Technical Service Bulletin

Cobra Moto, LLC

TSB0426 update 2 CX65 Cylinder Stay Bracket

Old dual bracket

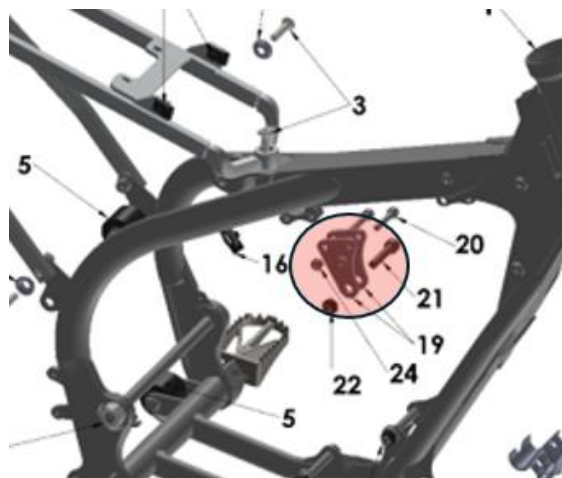
2024 – 2026 CX65's have two cylinder stay brackets (FCC60117) that are too rigid together. Combined they subject the frame and back of cylinder to too high of stress.

The "S" bracket is of insufficient strength. For now use only 1 of the aluminum (FCC60117) brackets and not two of them. They will ultimately fail but its easier and quicker to replace than a frame.
